SUBJECT: COMANCHE PEAK STEAM ELECTRIC STATION, UNITS 1 AND 2 -  
AMENDMENT NOS. 57 AND 43 TO FACILITY OPERATING LICENSE NOS.  
NPF-87 AND NPF-89 (TAC NOS. M99847 AND M99848)

TEXAS UTILITIES ELECTRIC COMPANY  
COMANCHE PEAK STEAM ELECTRIC STATION, UNIT 1  
DOCKET NO. 50-445  
AMENDMENT TO FACILITY OPERATING LICENSE

SAFETY EVALUATION BY THE OFFICE OF NUCLEAR REACTOR REGULATION

COMANCHE PEAK STEAM ELECTRIC STATION, UNITS 1 AND 2

FIGURE 2.1-1a

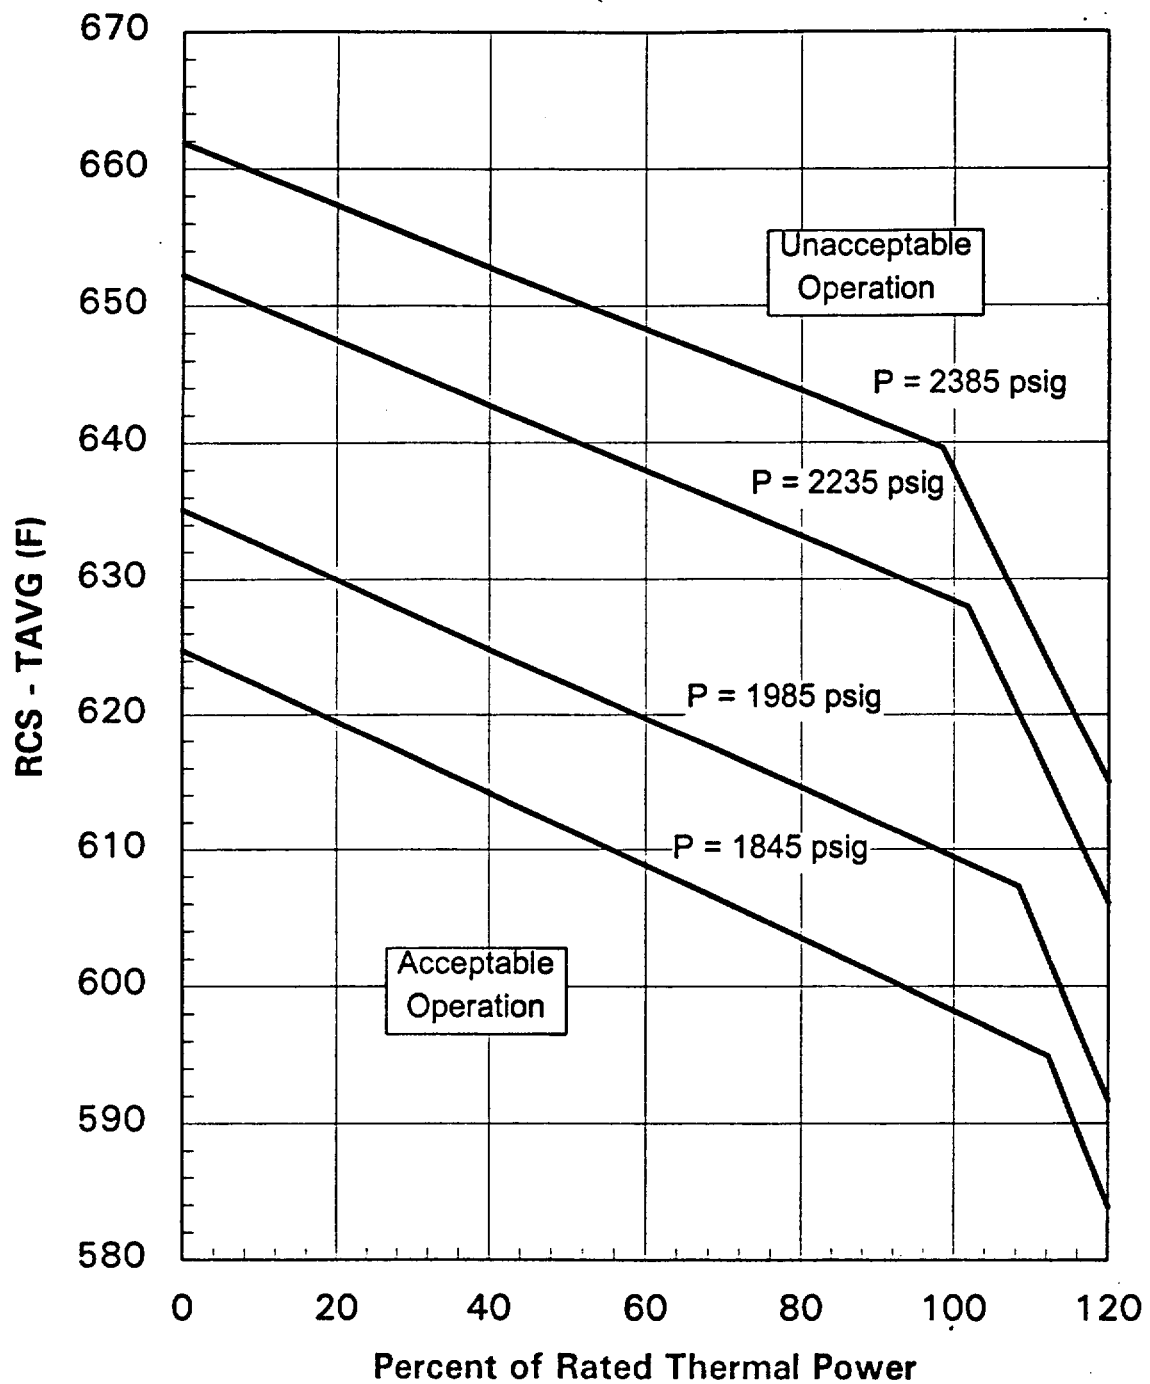
The licensee indicated that they used NRC-approved methodologies as stated in TS 6.9.1.6.b Items 9, 10, 11, 12, 13, and 14 to determine the new reactor core safety limit curves for Unit 1, TS figure 2.1-1a. The resultant core safety limit curves were evaluated by NRC-approved analytical methods to determine the appropriate values of  $K_1$ ,  $K_2$ , and  $K_3$ , coefficients of the overtemperature setpoint and the  $f(\Delta I)$  trip reset function as noted below:

The licensee has requested to change TS Figure 2.1-1a, Unit 1 Reactor Core Safety Limits and TS Table 2.2-1, "Reactor Trip System Instrumentation Trip Setpoints," Units 1 and 2 to accommodate changes due to the designed core configuration for Unit 1, Cycle 7. The staff has reviewed the changes to verify that all safety criteria have been satisfied. The proposed revisions to the safety limit curves and the trip setpoints, and the use of NRC-approved methodologies will provide assurance of DNB margin. Therefore, the staff finds the licensee's requested changes acceptable.
